Request for Pricing / Date: 10/6/2026 / Rev 1

Project: **Sunrise Rye Brook - 900 King St, Rye Brook, NY 10573**

Mechanical drawings: GMP set dated 07.15.2026 (value engineering revisions below)

Request for revised pricing - value engineering

INDEPENDENT LIVING**FIRST FLOOR PLAN -****MECHANICAL IL AREA****M2010**

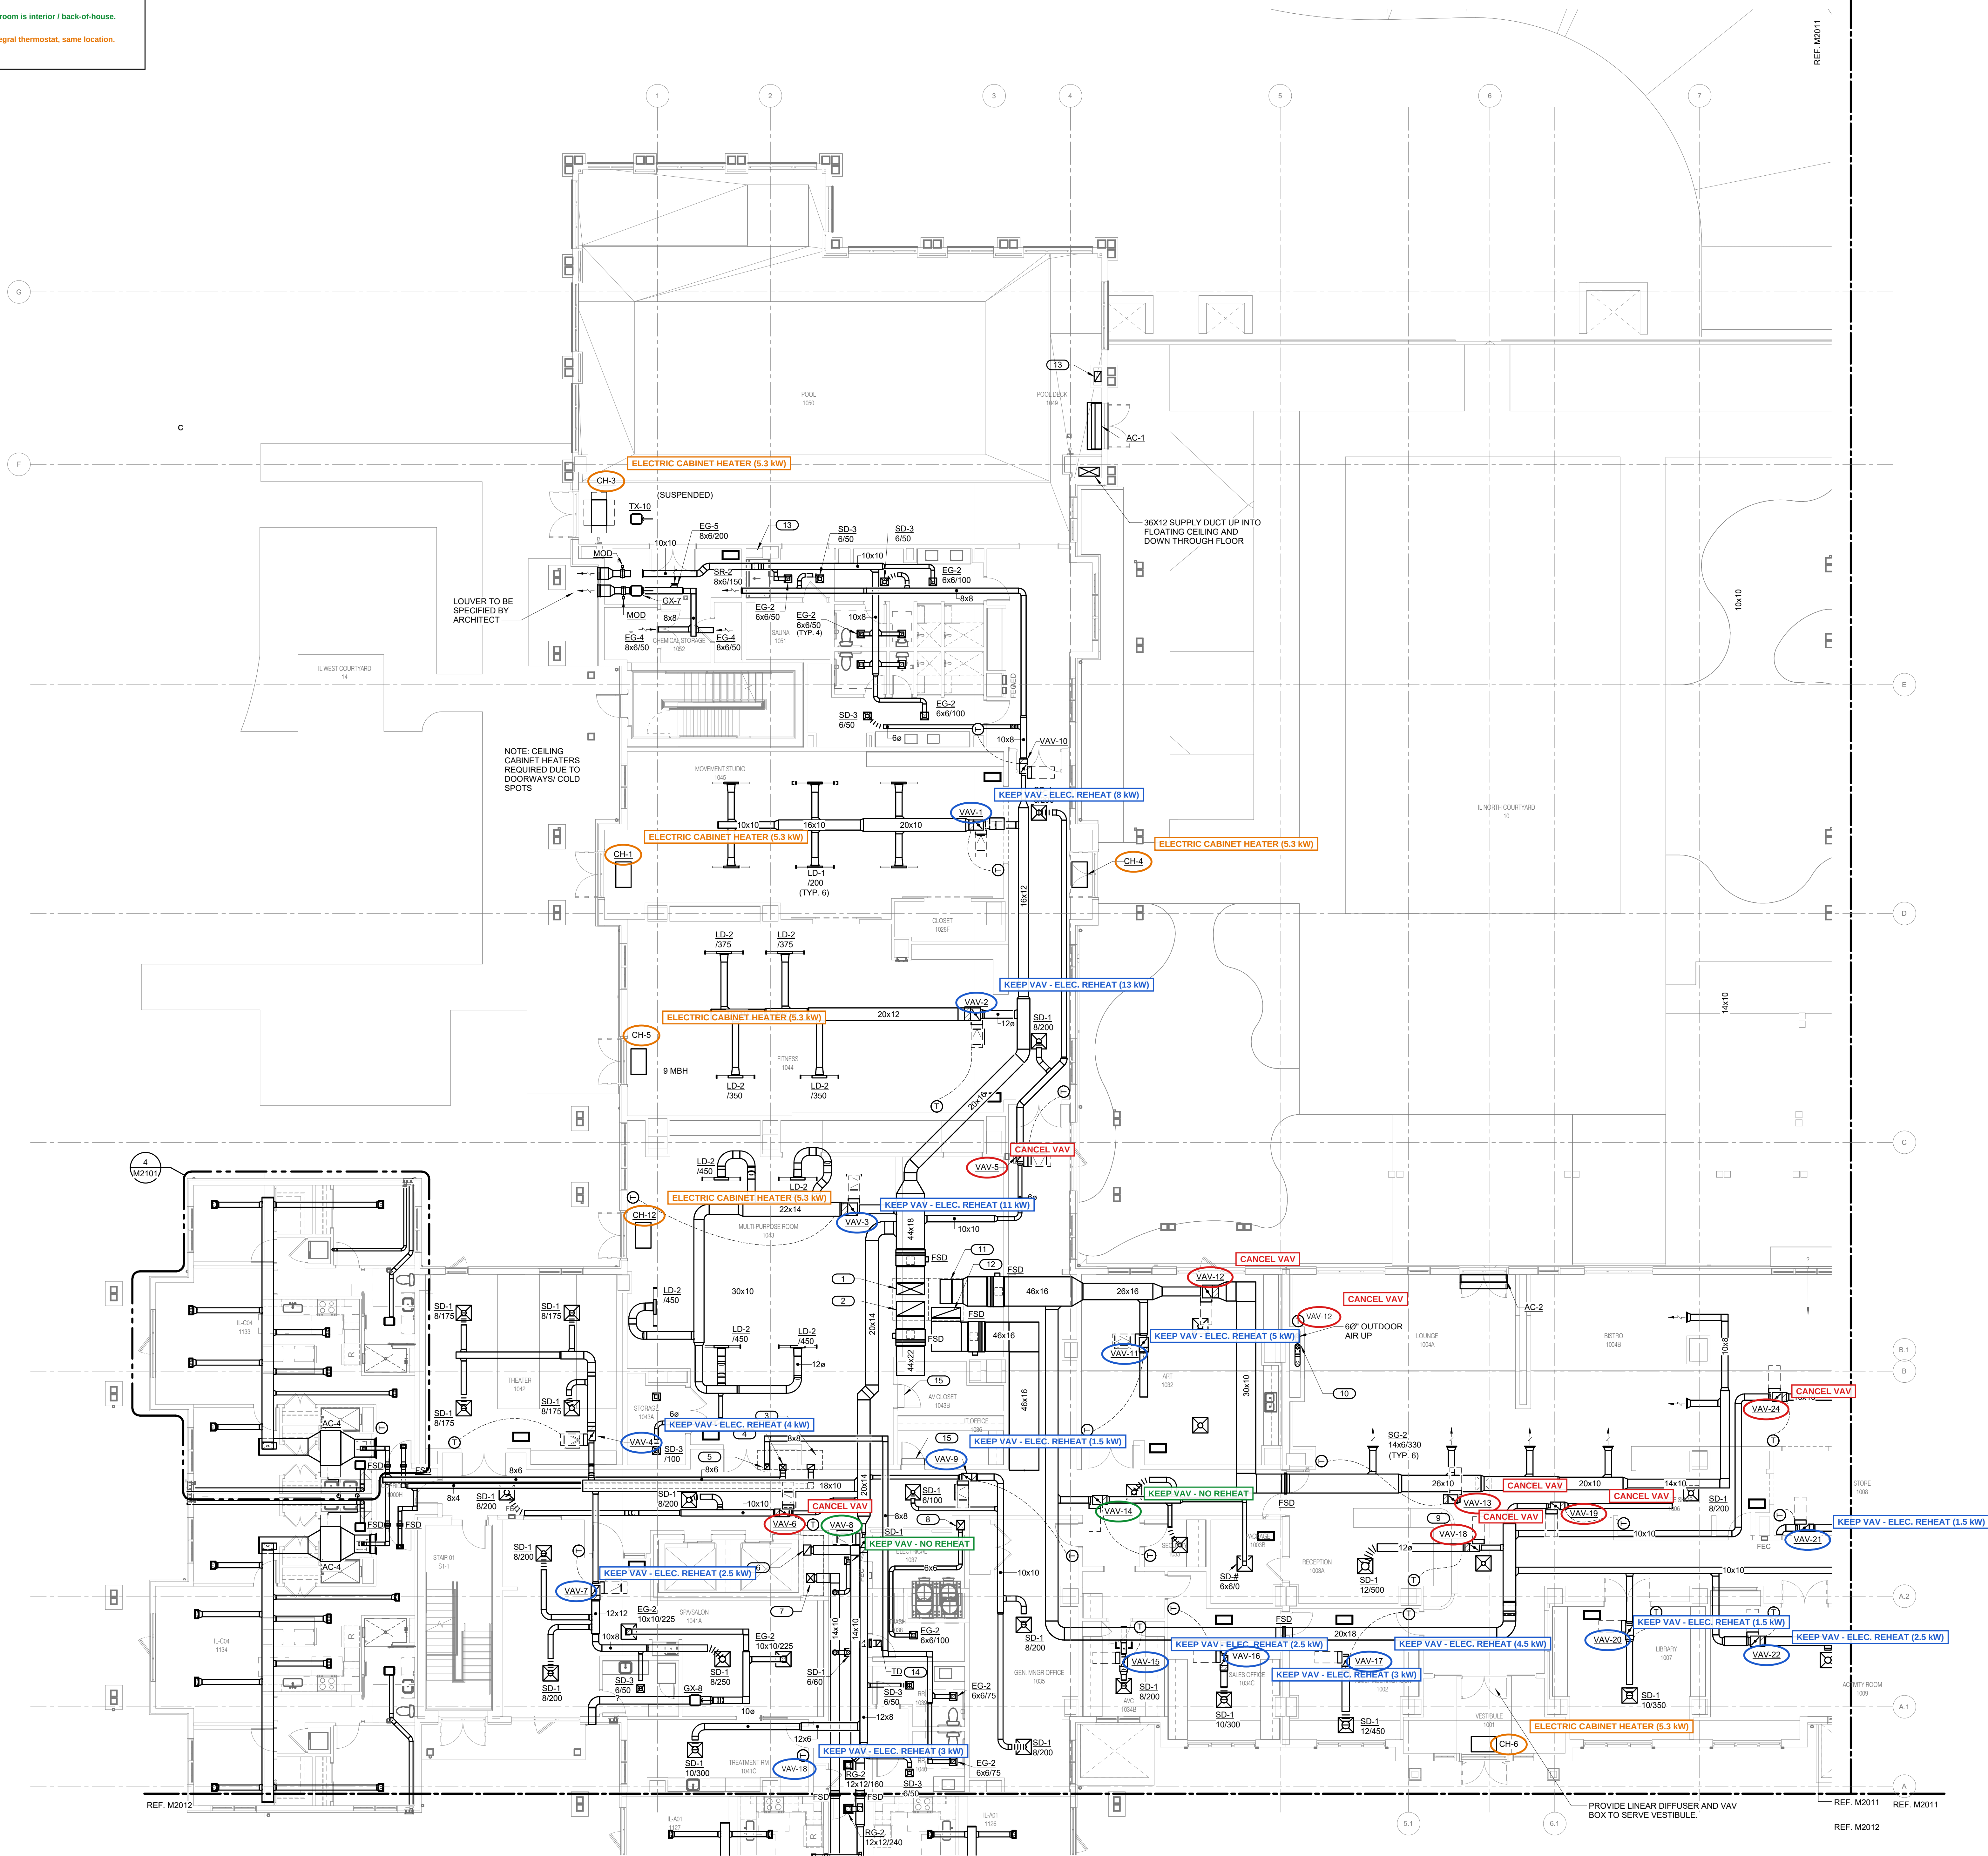
The heating design is being revised from a hot water boiler plant to electric heat. Please provide revised pricing for the items below: new items (section 1 and 2), credits for items deleted from your previous quote (section 3) and alternate deducts (section 4). Quote per line in the attached xlsx, with lead times. Electric heat at 208 V, kW rated at 208 V (not 240 V units derated): VAV electric reheat coils up to 5 kW at 208 V / 1 ph, above 5 kW at 208 V / 3 ph (voltage listed per box); cabinet and unit heaters at 208 V / 3 ph (note any item only available 208 V / 1 ph). Controls are standalone (no BMS): factory-mounted standalone controllers with wall thermostats / sensors.

1. VAV terminal units (1st floor common areas)

1A. Single-duct VAV with factory electric reheat coil, SCR control, airflow switch, disconnect, standalone pressure-independent controller and wall thermostat (26)

Tag	Room served	Inlet	Max CFM	Min CFM	Elec. heat	Volts / ph
VAV-1	Movement Studio 1045	12"	1200	825	8 kW	208/3
VAV-2	Fitness 1044	14"	1450	1350	13 kW	208/3
VAV-3	Multi-Purpose Room 1043	14"	2250	1150	11 kW	208/3
VAV-4	Theater 1042	8"	700	375	4 kW	208/1
VAV-7	Spa / Salon 1041A	10"	700	250	2.5 kW	208/1
VAV-9	Gen. Manager Office 1035	8"	350	150	1.5 kW	208/1
VAV-10	Locker rooms	6"	425	250	3 kW	208/1
VAV-11	Art 1032	10"	550	500	5 kW	208/1
VAV-15	AVC 1034B	6"	200	200	2.5 kW	208/1
VAV-16	Sales Office 1034C	6"	300	250	3 kW	208/1
VAV-17	Family Meeting Room 1002	8"	450	450	4.5 kW	208/1
VAV-18A	Treatment Rm 1041C	TBD	TBD	TBD	3 kW	208/1
VAV-20	Library 1007	8"	350	150	1.5 kW	208/1
VAV-21	Store 1008	8"	300	150	1.5 kW	208/1
VAV-22	Activity Room 1009	12"	900	250	2.5 kW	208/1
VAV-26	Private Dining 1016	6"	400	200	2.5 kW	208/1
VAV-30	Private Dining 130 / Dry Storage	6"	350	200	2.5 kW	208/1
VAV-38	Family Room 120	8"	450	300	3.5 kW	208/1

VAV-39	Work Room / Sales / Exec. Director	6"	400	250	3 kW	208/1
VAV-41	Salon 132A	8"	400	150	1.5 kW	208/1
VAV-42	Theater 135	12"	600	200	2.5 kW	208/1
VAV-43	Activity 136	14"	1000	400	4 kW	208/1
VAV-44	Fitness 141	16"	1100	500	5 kW	208/1
VAV-45	Fitness / Wellness Office	8"	450	350	3.5 kW	208/1

Tag	Room served	Inlet	Max CFM	Min CFM	Elec. heat	Volts / ph
VAV-46	Wellness Office	6"	400	200	2.5 kW	208/1
VAV-47	Exam / AVC Office	6"	450	300	3 kW	208/1
Total					100 kW

Heating airflow at the scheduled minimum CFM; confirm minimum airflow for the electric coil. VAV-18A: second VAV-18 tag on M2010 (Treatment Rm 1041C), size per vendor at 3 kW.

1C. VAV boxes cancelled - credit (18)

Tag	Room served	Inlet	Max CFM	Min CFM
VAV-5	Corridor / gallery	8"	400	400
VAV-6	Corridor	8"	400	400
VAV-12	Lounge 1004A	14"	1300	1300
VAV-13	Lounge / Bistro 1004A-B	10"	600	600
VAV-18	Reception 1003A	8"	500	500
VAV-19	Coffee Shop 1006	6"	200	50
VAV-24	Bistro 1004B	10"	550	200
VAV-23	Restrooms 1012-1013 / Mailroom	6"	300	100
VAV-25	Casual Dining 1015	14"	3000	1100
VAV-27	Formal Dining 1017	14"	1850	425
VAV-28	Restrooms / kitchen corridor	10"	800	525
VAV-29	Main Kitchen 1019	16"	1800	600
VAV-33	AL Dining 128	16"	2500	1000
VAV-34	Bistro 127	14"	1200	450
VAV-35	Bistro / dining 127	6"	200	200
VAV-36	Parlor 131	8"	350	150
VAV-37	Reception 126	8"	250	150
VAV-40	Corridor 100C	6"	200	100

2A. Electric cabinet unit heaters, wall / ceiling as scheduled, with integral thermostat, disconnect and fan (10)

Tag	Location	Heat	Fan CFM (as scheduled)
CH-1	Movement Studio entry	5.3 kW	450
CH-3	Pool deck / stair entry	5.3 kW	450
CH-4	Exterior door at gallery	5.3 kW	450
CH-5	Fitness entry	5.3 kW	450
CH-12	Multi-Purpose Room entry	5.3 kW	450
CH-6	Vestibule 1001	5.3 kW	450
CH-7	Formal Dining entry	5.3 kW	450
CH-9	Trash 1030 / Storage	10.4 kW	1,050
CH-10	Casual Dining entry	5.3 kW	450
CH-11	Casual Dining entry	5.3 kW	450
Total		58.1 kW
